FINAL DRAFT MINUTES

January 18, 2024, Standards Committee Meeting

RE: Minutes from the January 18, 2024, Standards Committee Meeting

E 801-TPAR-09 PEDESTRIAN DIVERSION, STREETSIDE AT INTERSECTION (proposed new)

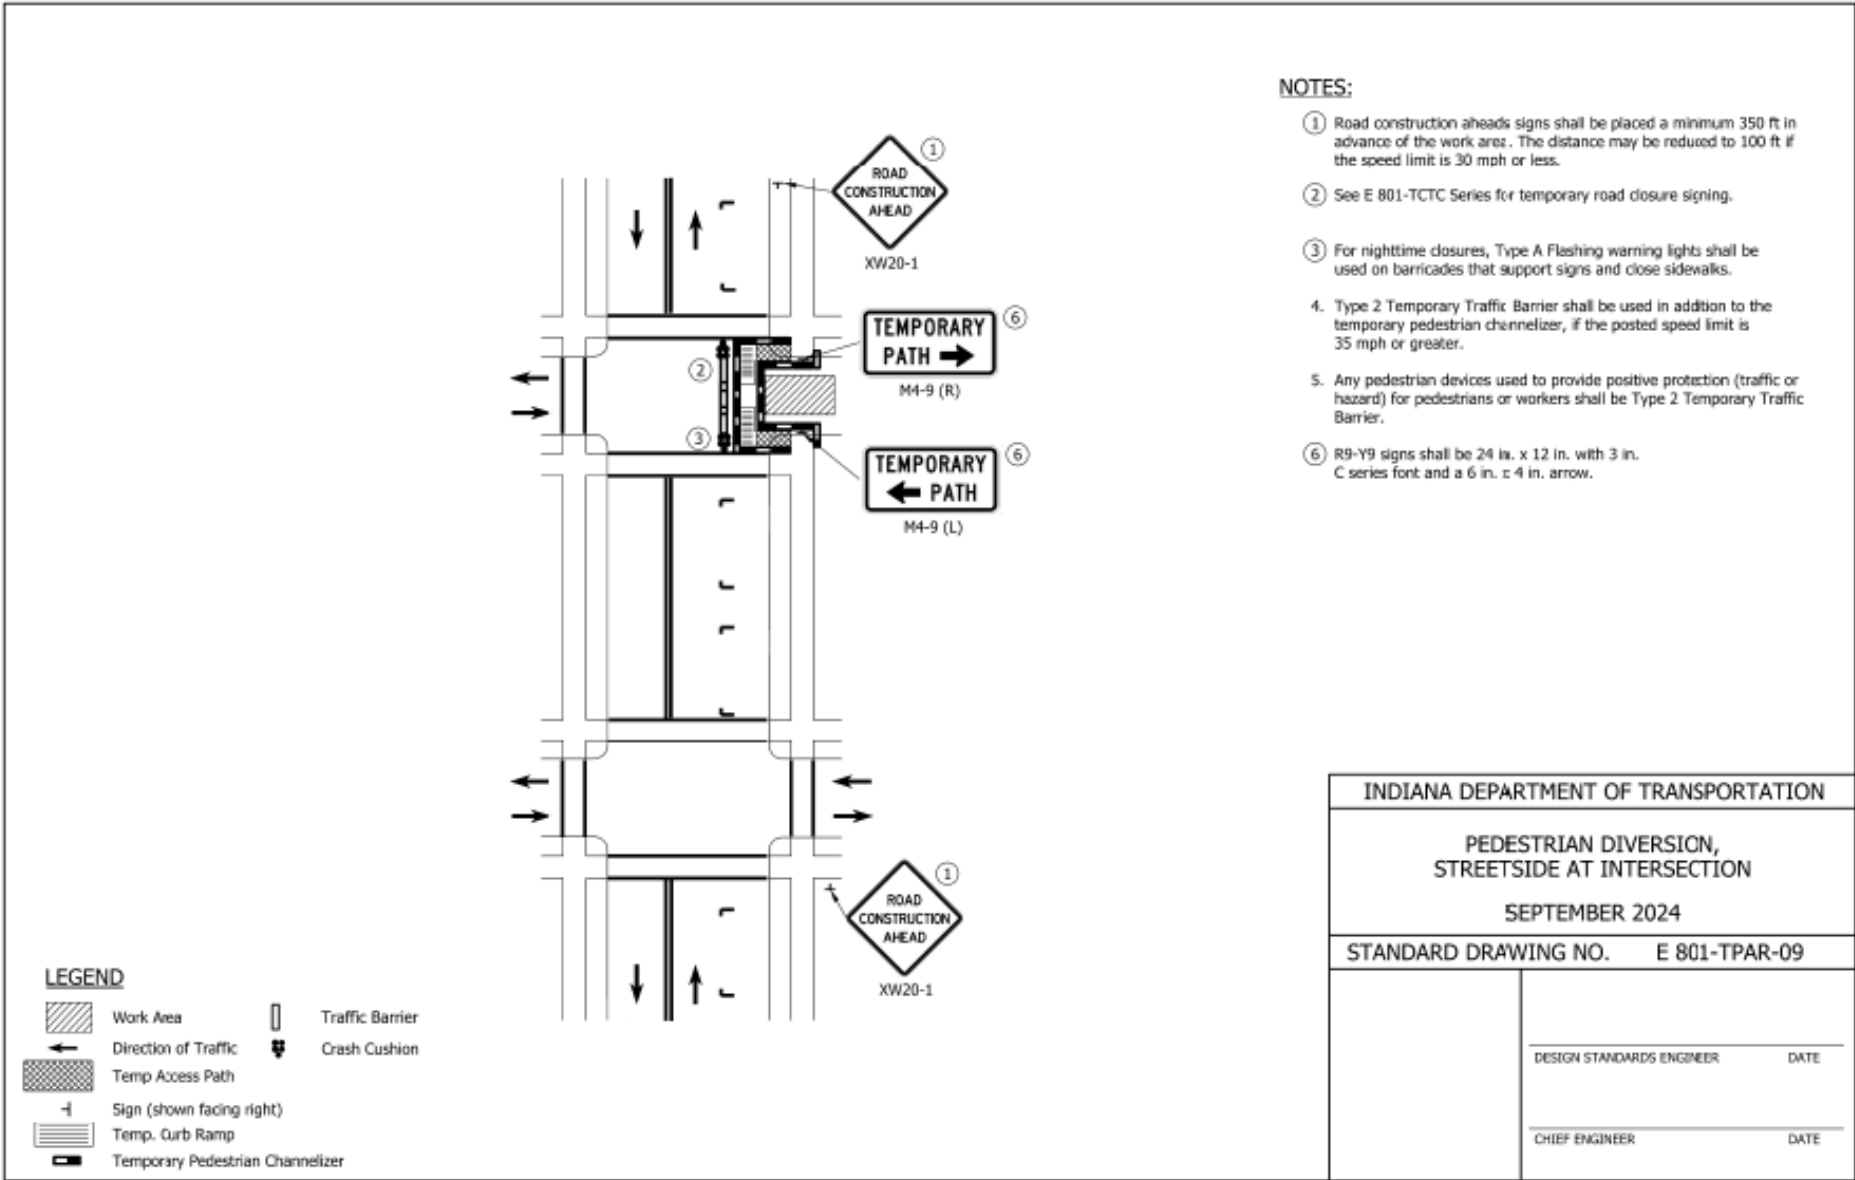
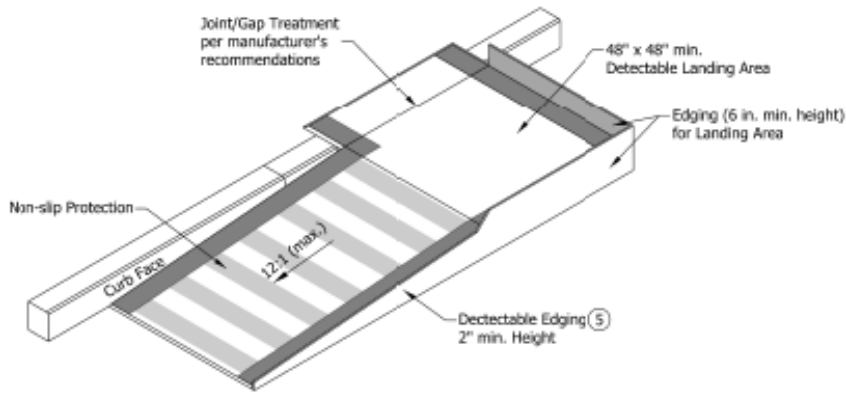
Mr. Koch stated, concerning the 801-TPAR drawings-02, -04, -05, -06, -07, -08, -10: everyone has RCA's. In order to minimize costs, burdens, and liability if the note is overlooked, and the associated costs to change out signage as the work progresses and to maintain a stock of the signs; please consider striking note #2. Also, for drawings 801-TPAR-03, -05, -07, understand we are attempting to capture both approaching sidewalks yet we are adding a considerable amount of sign clutter. Are two RCA's needed as a single is utilized elsewhere? And for 801-TPAR-10, the corner diversion requires 'sidewalk construction ahead' yet includes note #2. Similar to elsewhere, should RCA's be required 1st, ideally only RCA's for simplification. Mr. Boruff responded that we could make it an option, which would eliminate the liability and added costs concerns. The Contractor can use RCA's if they have them in stock or would otherwise prefer the alternate, more precise message. Mr. Koch said that sounds reasonable. The drawings have been revised as shown, following discussions by Mr. Duncan from FHWA, Mr. Koch, Ms. Smutzer, Mr. Davis, and Mr. Boruff.

E 619-PRWS-03 COATING REQUIREMENTS FOR EXISTING STRUCTURAL STEEL ENCASED IN CONCRETE (proposed draft, revised)

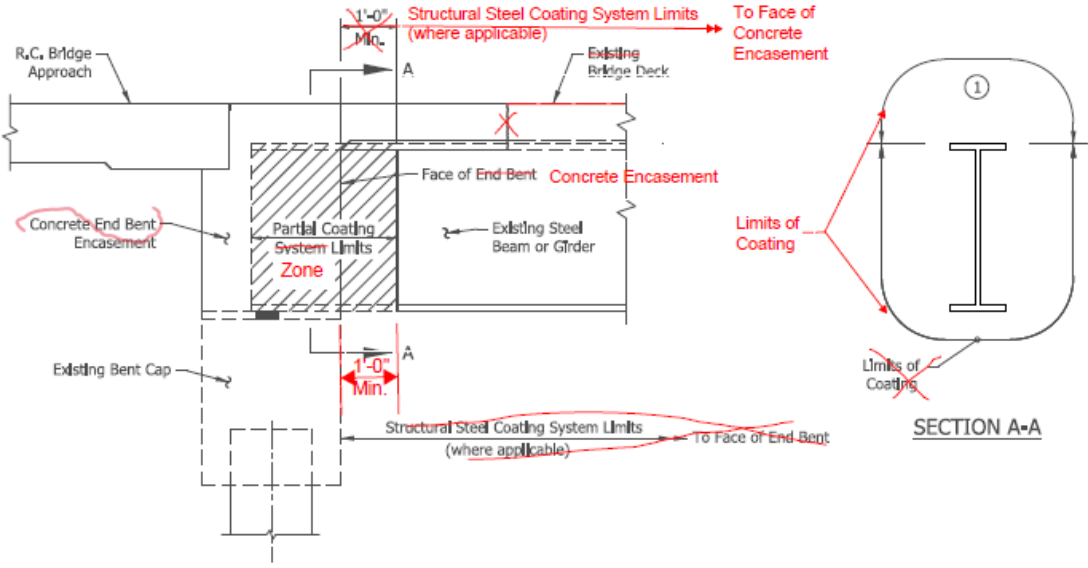
Ms. Mouser showed revised drawings and explained the revisions (E 619-PRWS-03).
 Mr. White proposed the acceptance of the drawings revised as shown.
